# CLOVERLEAF FILING 2

# STORM SEWER AND POND PLANS

AS-BUILTS  
05/24/2023  
SF-21-023

# V1\_As-Built Construction Drawing.pdf Markup Summary

**CRIMSON CLOVER DRIVE PROFILE 3  
STA 0+00.00 TO 7+50.00**

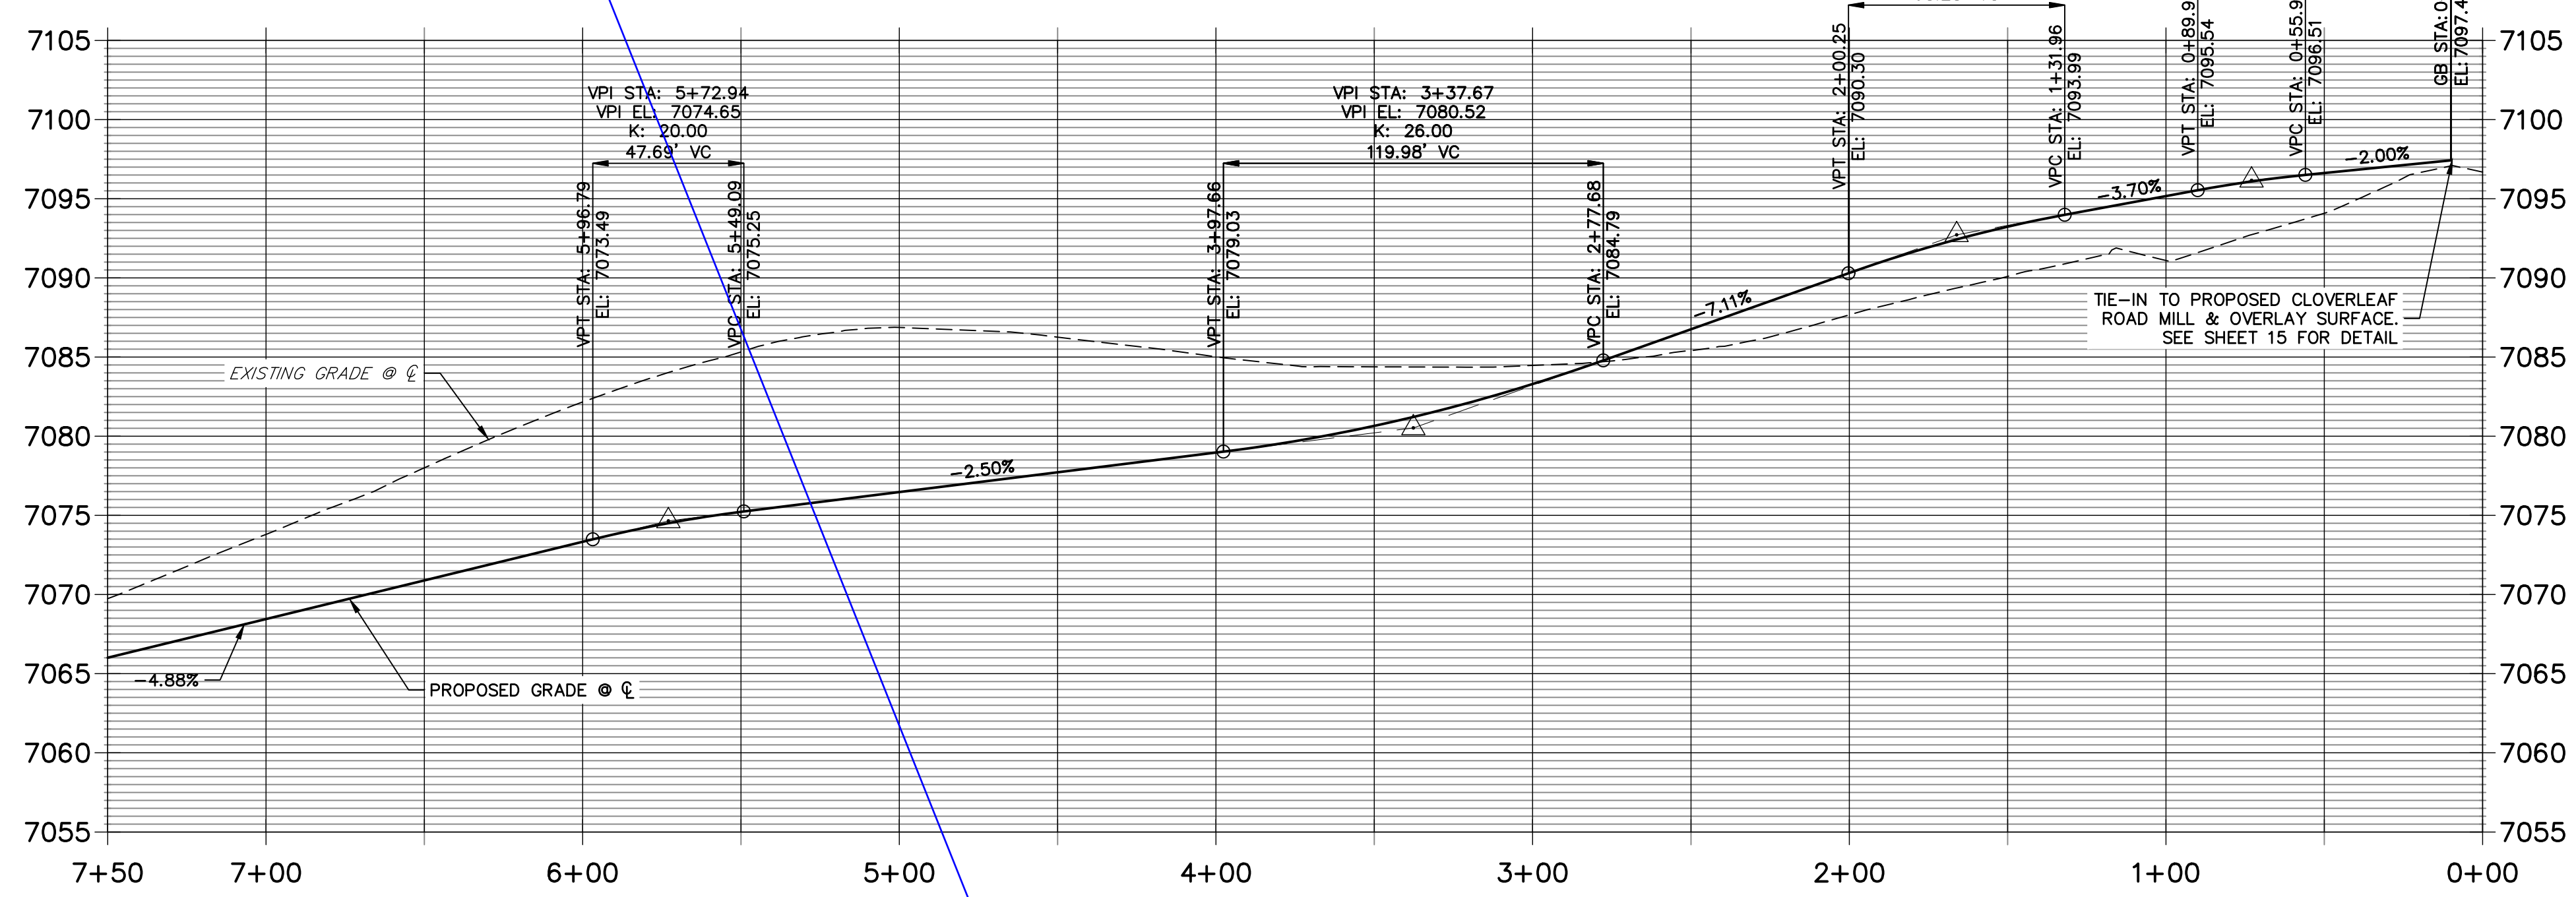
Show where the sidewalk goes around the inlet

**ALSIKE CLOVER COURT PROFILE 2  
STA 6+50.00 TO 13+00.00**

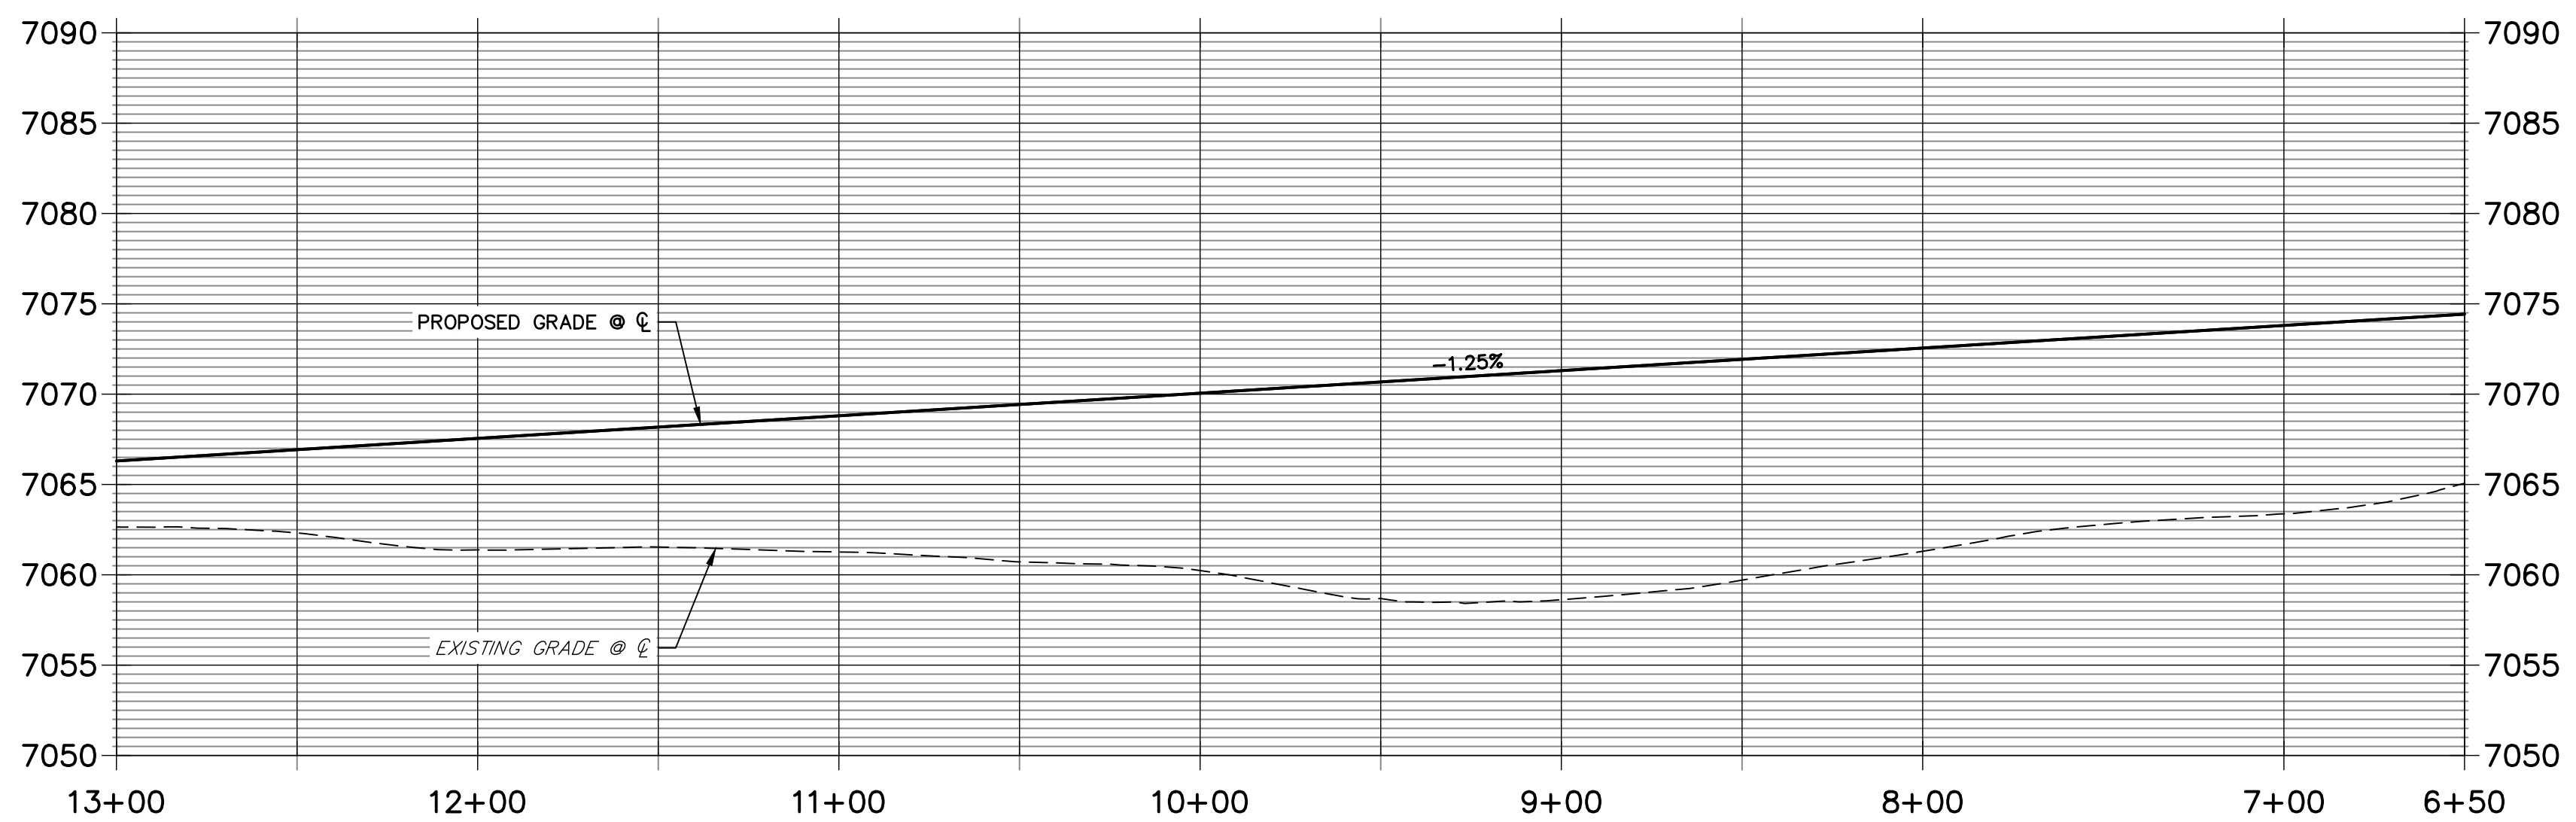
Show where the sidewalk goes around the inlet
